25/02/2026
Our Ref: 24-1057

Re: Redleaf Orange – DA Engineering RFIs and Design Amendments

This letter is an addendum to the original Water Cycle Management Report (24-1057-Water-Cycle-Management-Report-DA-C) prepared by Colliers Engineering & Design (CED), submitted as part of the development application for the Redleaf project.

Figure 1: Approx extent of Flood Assessment Addendum

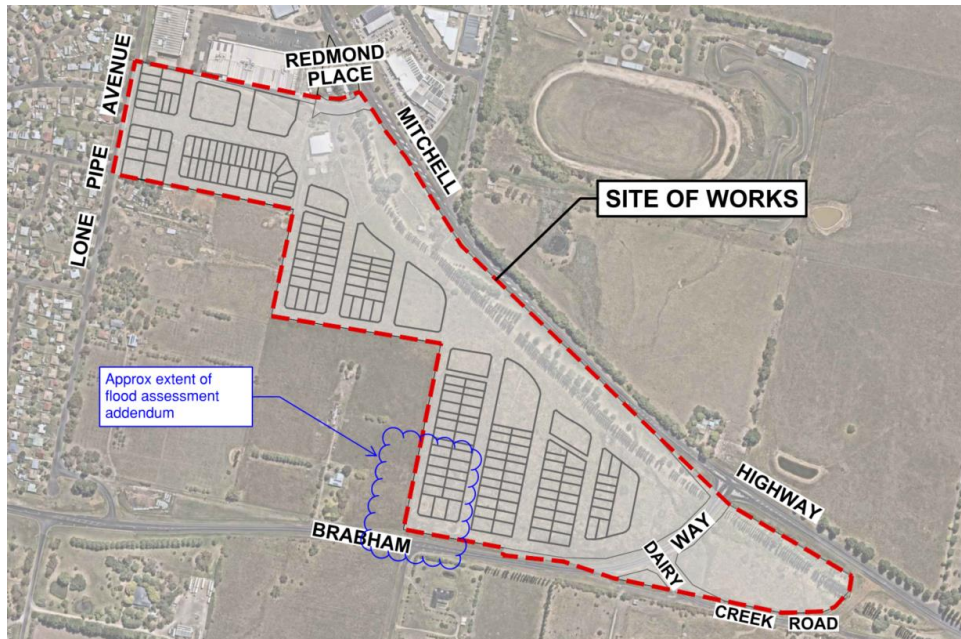
This flood assessment focuses solely on the south-western boundary where the external overland flow path intersects the site as highlighted in Figure 1.

The revised site layout amendments are limited to internal areas and are minor in scope. As such, it is anticipated that there will be no material change in the flood behaviour associated with the proposed development. Hence, the findings and conclusions presented in the original Water Cycle Management Report remain valid and unchanged.

Figure 2: Updated DA Road and Drainage Plan along Road No.04

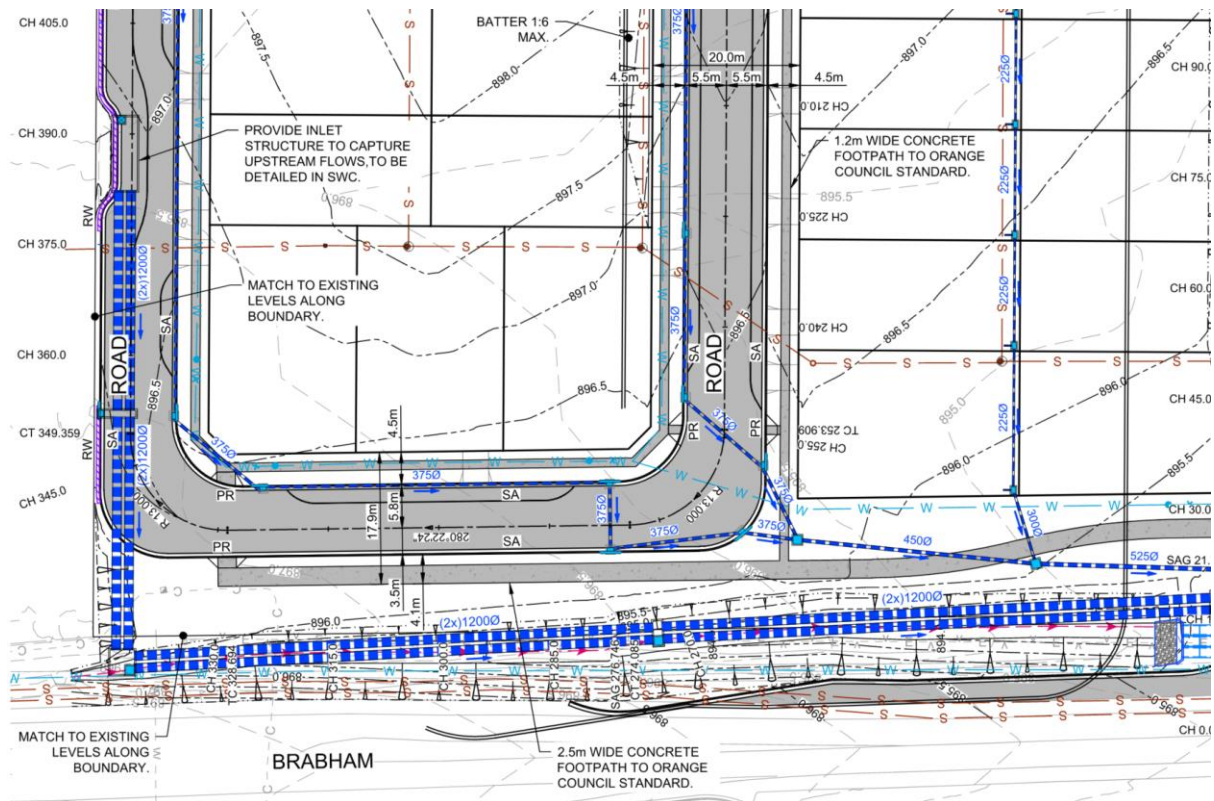
“We are currently undertaking an engineering assessment of the Redmond PI plans and note there is a retaining wall of 1.5m – 2m traversing the western side of Road 4 with a stormwater inlet structure (Sheet 741) beneath the road. This structure was never discussed in our previous meetings.

Council wont accept that as a solution for the stormwater coming into the site at Chainage 390 (Road 4) from the west, you will need to find another solution.

During the assessment of the originally submitted development application, Council made comments, quoted above, of not supporting the civil design, particularly around the south-west portion of the site, due to the large retaining walls and inlet structure. Concerns were raised based on a number of factors including safety, maintenance, and effectiveness of the design.

Following meetings with Council to discuss the original design submitted as part of the development application, it was concluded that the Road No.04 at the south-west portion of the site be lowered such that levels begin to match existing levels along the boundary. The intention of this is to allow a portion of the external overland flow path to overtop onto the road and be conveyed by the road until the kerb is overtopped at the sag point and subsequently directed into the existing roadside swale along Brabham Way, which is proposed to be widened with a 3m base as part of the additional works undertaken.

In addition to lowering Road No.04, it was also concluded that the road be adjusted at the intersection of the external flow path and the site. It was proposed that the road blister into the site to create a cut-out opening for water to flow into the site rather than

it be captured at the boundary. This was proposed to allow water to be contained entirely within the site and not impact the adjacent property.

The updated civil design changes can be seen in the updated DA drawing set and in the Figure 2 below. The updated DEM relating to the updated civil design changes can also be seen in Figure 3.
